# NEBRASKA CAPITOL ENVIRONS COMMISSION

## AGENDA

## NEBRASKA CAPITOL ENVIRONS COMMISSION STAFF REPORT

## NEBRASKA CAPITOL ENVIRONS COMMISSION STAFF REPORT

119+00

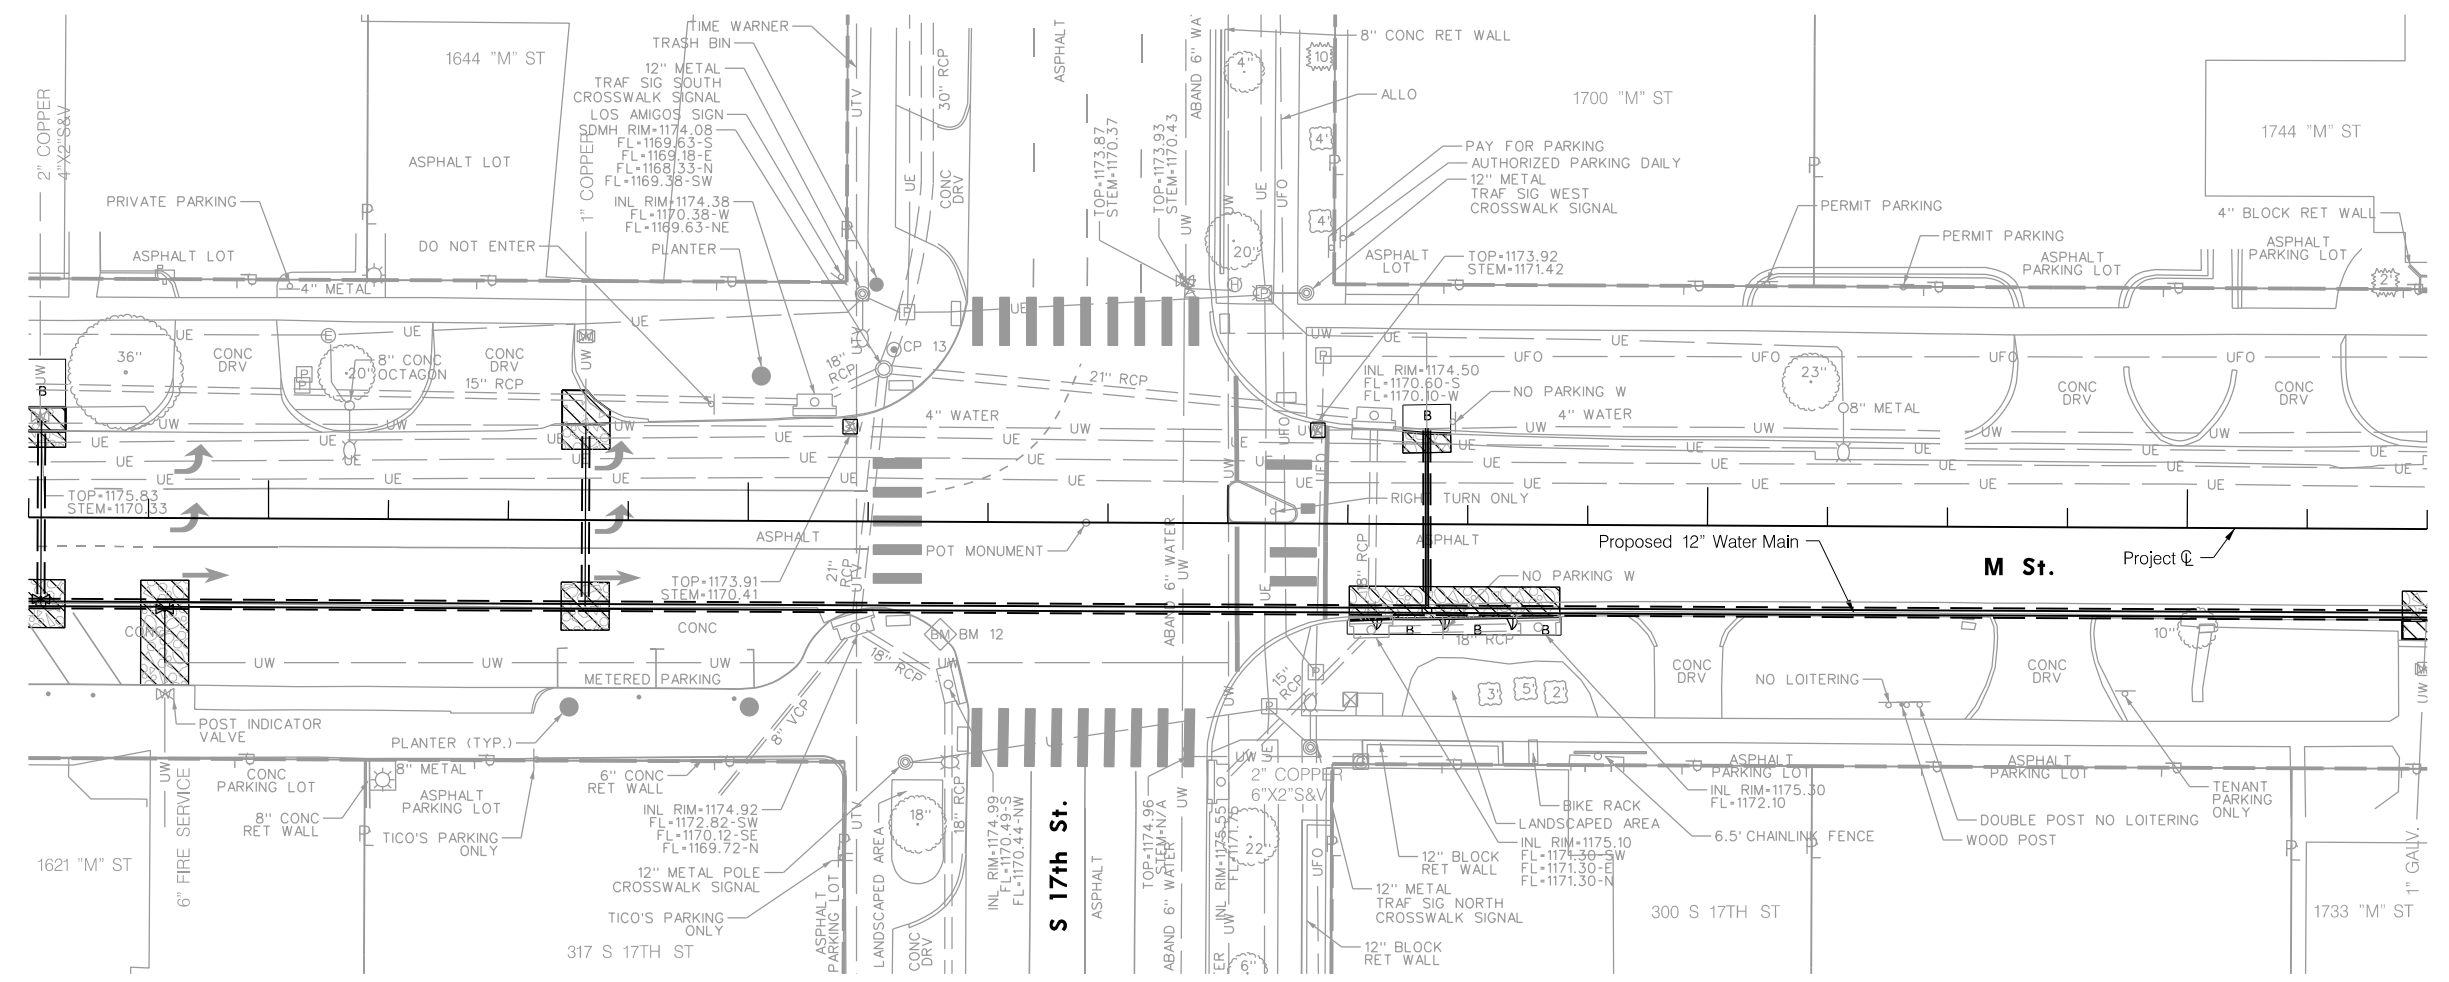
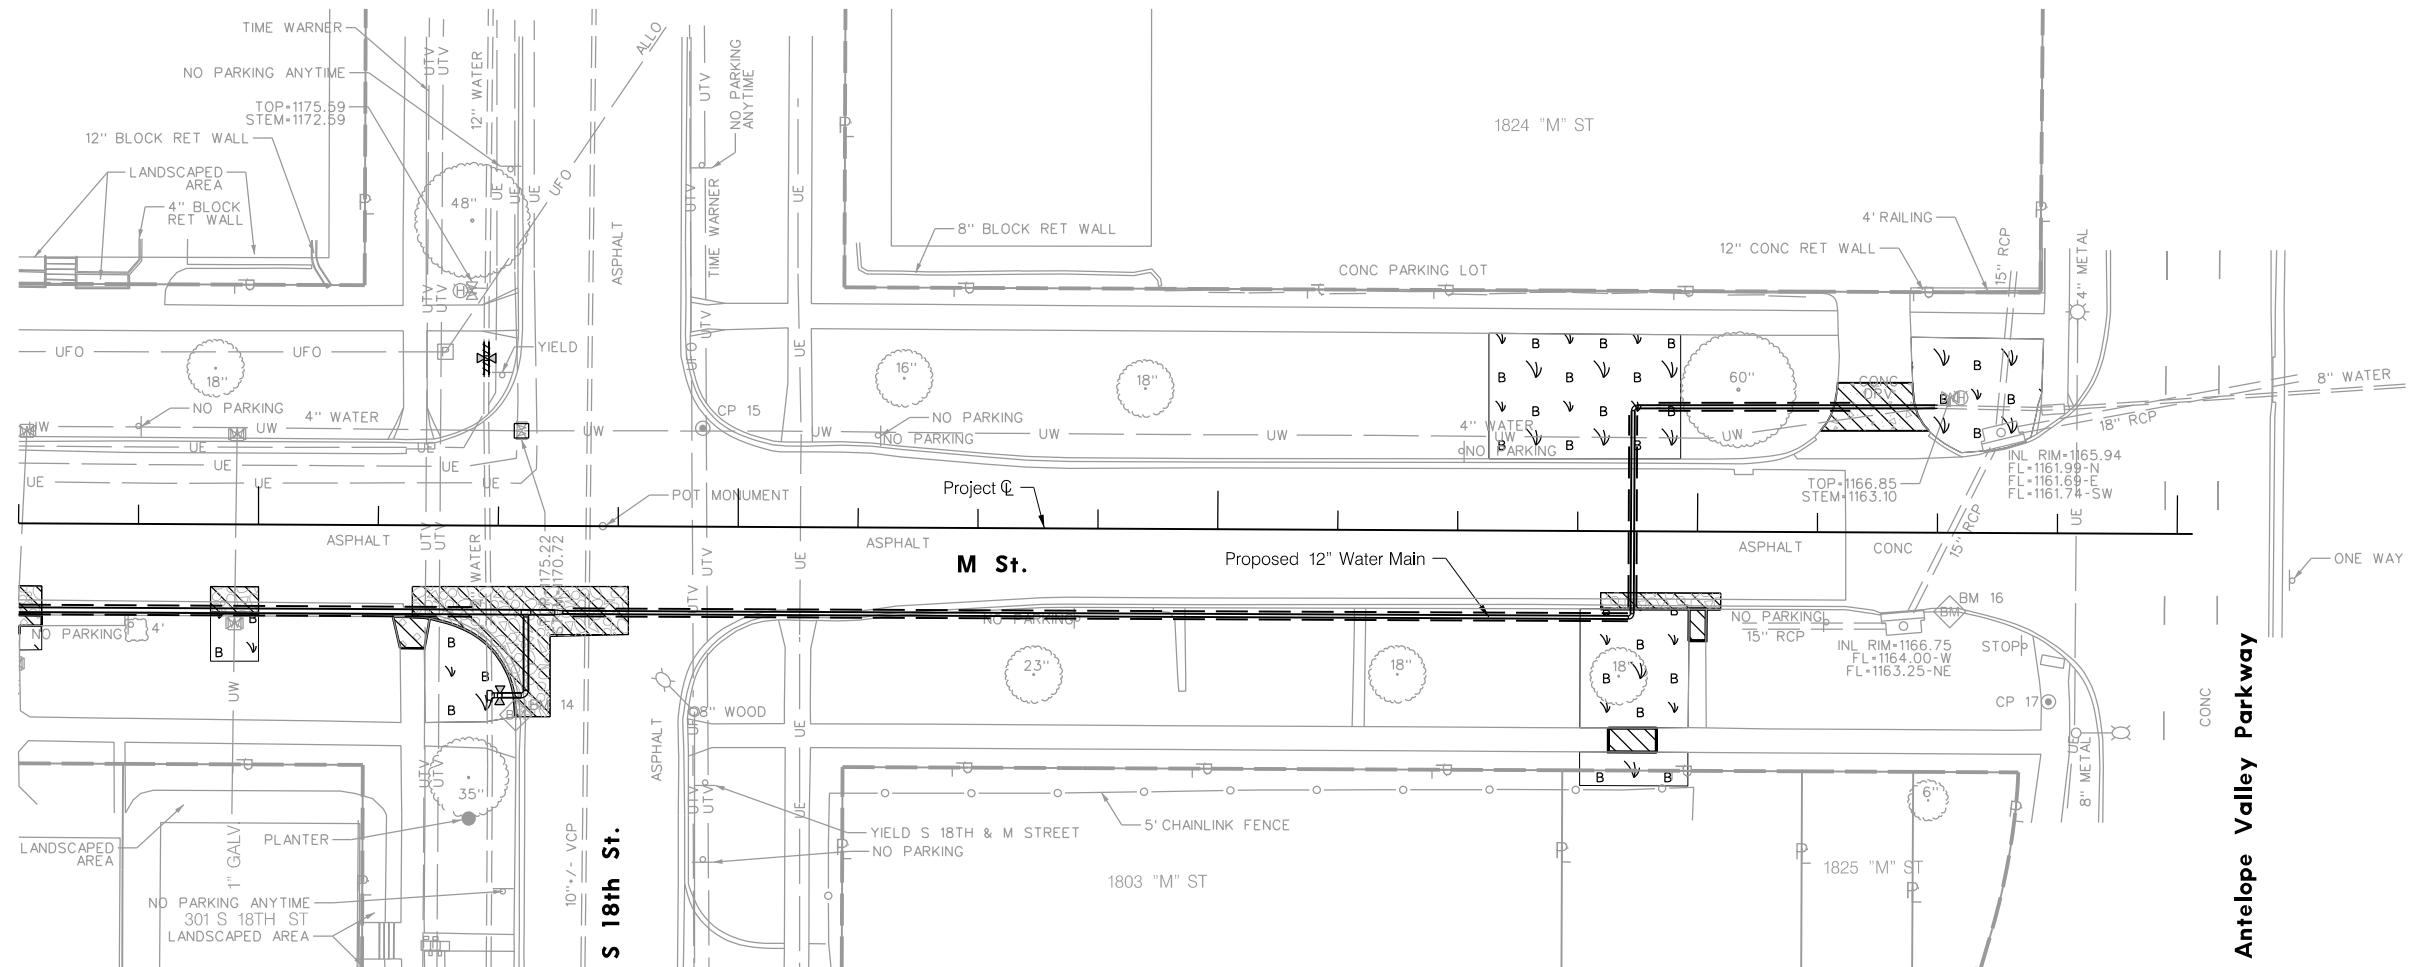
Lincoln Transportation and Utilities (LTU) is planning a water main replacement project for the south side of M Street from S 13<sup>th</sup> Street to Antelope Valley Parkway. This project intersects the Capitol Environs District from S 14<sup>th</sup> to S 16<sup>th</sup> streets. In reviewing the plans for the project, staff is of the opinion that the project will not have any long-term impacts on the Environs District. No trees are being removed, and the method for replacing the water main will result in limited impacts to the landscapes and hardscapes.

Given the nature of this project – an underground utility project resulting in minor impacts on the above-ground streetscape – there is not much in the standards that would apply. Ultimately, the key consideration will be LTU’s ability and commitment to properly restoring any landscape or hardscape elements disturbed in the construction process, returning the above-ground project area to its original state.

**Recommended action:** Approval of a Certificate of Appropriateness for the M Street water main replacement project.
